Proton Developments (SA) Pty Ltd

Variation to DA 020/A037/16 for demolition of existing buildings and structures, and construction of a mixed use building. Variation: removal of basement 2; additional car park level above ground; increased height; removal of commercial use; some internal alterations; revised roof parapet and alterations to materials.

55 Hutt Street, Adelaide

020/A037/16 V4

OPUS ON HUTT SECTION COMPARISON

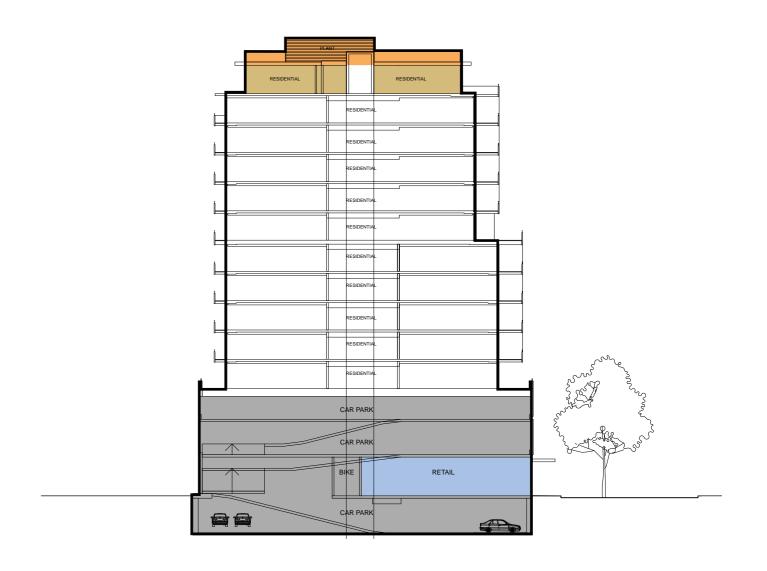
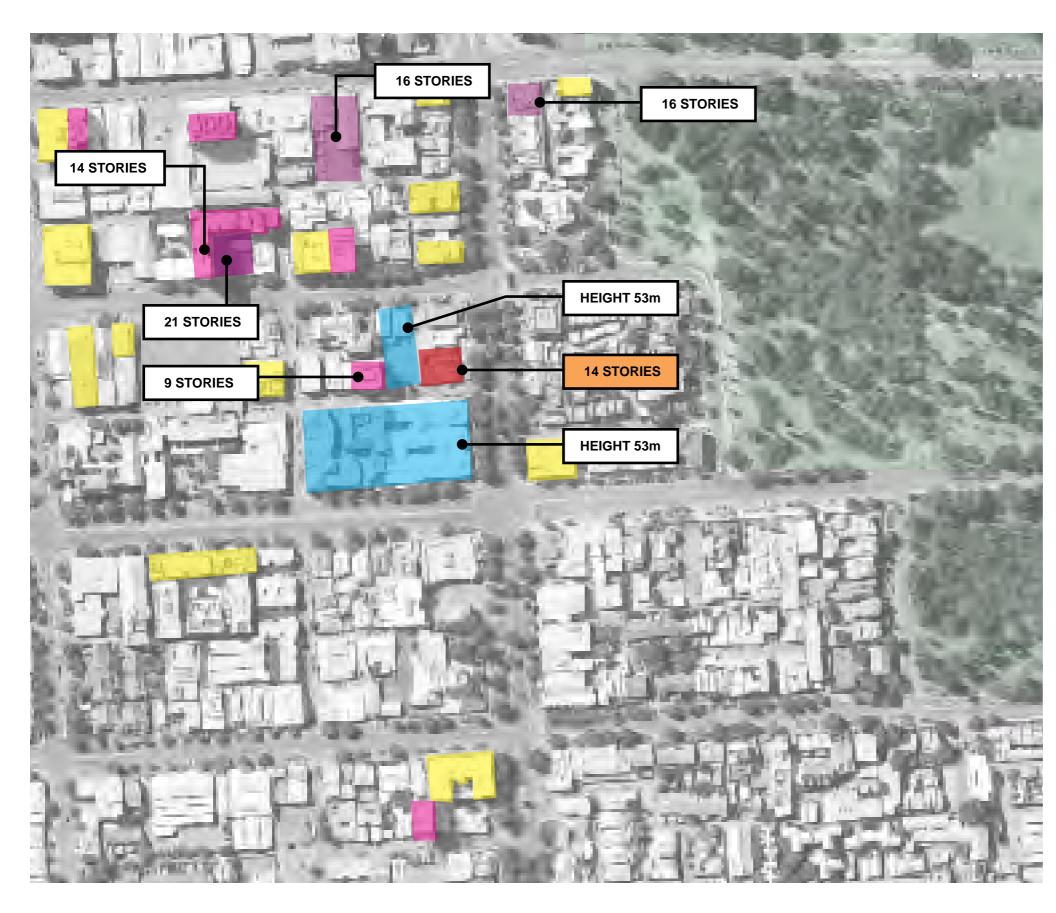
- Basement 2 deleted.
- Additional carpark level above ground.
- Increased retail height.
- Deletion of level 1 commercial.
- Revised penthouse plan from 1 to 2 apartments.
- Revised roof and parapet.

FACADE DIAGRAM

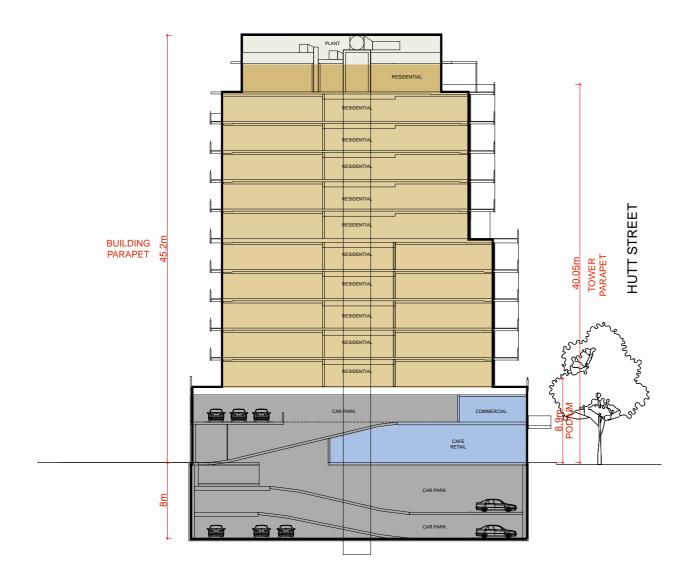
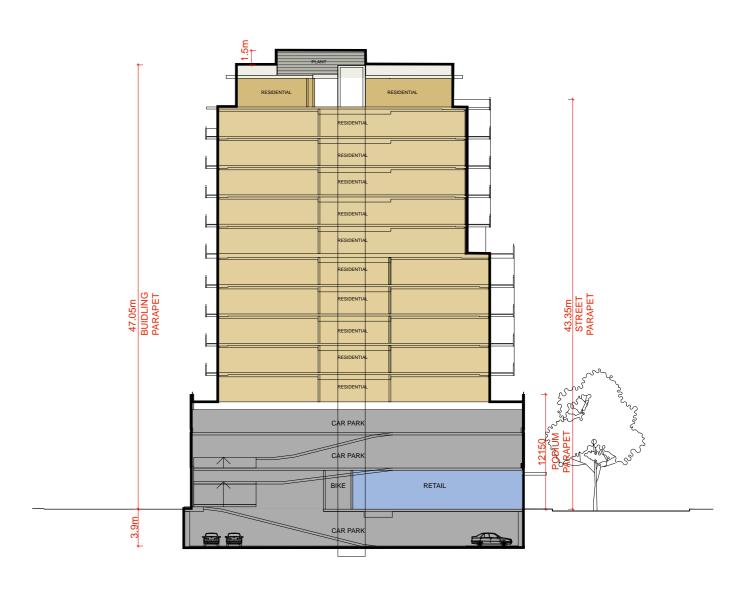
- The proposed screening is highly detailed and articulated to respond to the scale and rhythm of the existing streetscape
- Success of the proposed screens as part of the overall architectural expression relies on precise and high quality material selection and detailing

Facade articulation transitioning from a heavy screen to a lighter screen

Approved DA - Bartels Road looking west

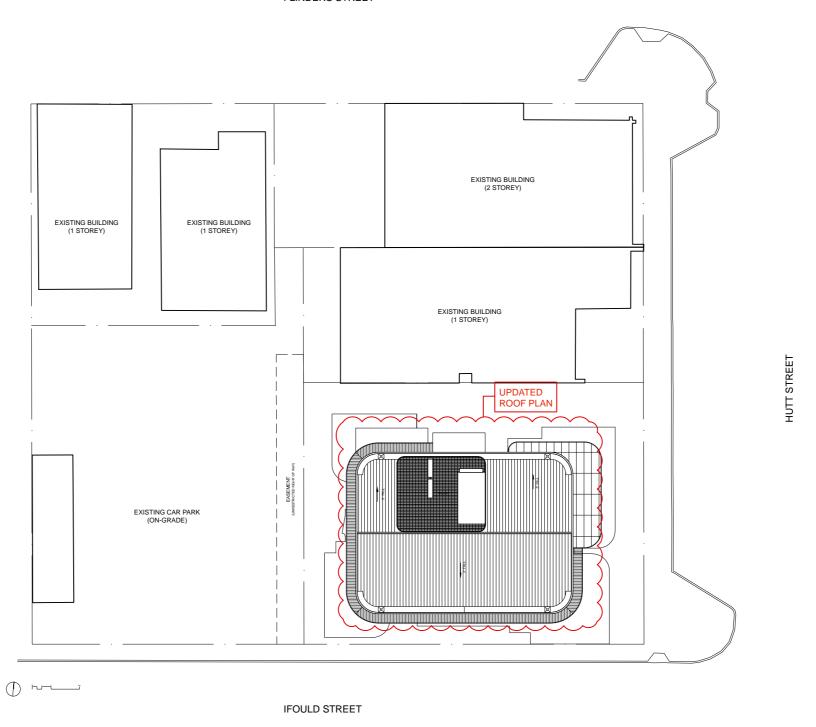
- Support for the overall building height on balance, however, any further increase beyond the proposed height of 48.15m will not be supported
- The new arrangement to the roof top plant deck, roof parapet and louvered screen does not integrate the plant enclosure into the roof structure as originally intended, however on balance supports the amendment as it is setback from the roof parapet edge to minimise its visual impact

The currently approved building has a height of 45.2m with the proposal seeking to increase in height to 48.15m (as a result of removing 1 level of basement parking and placing it above ground). This is an increase in height of 2.95m (or 7.4%).
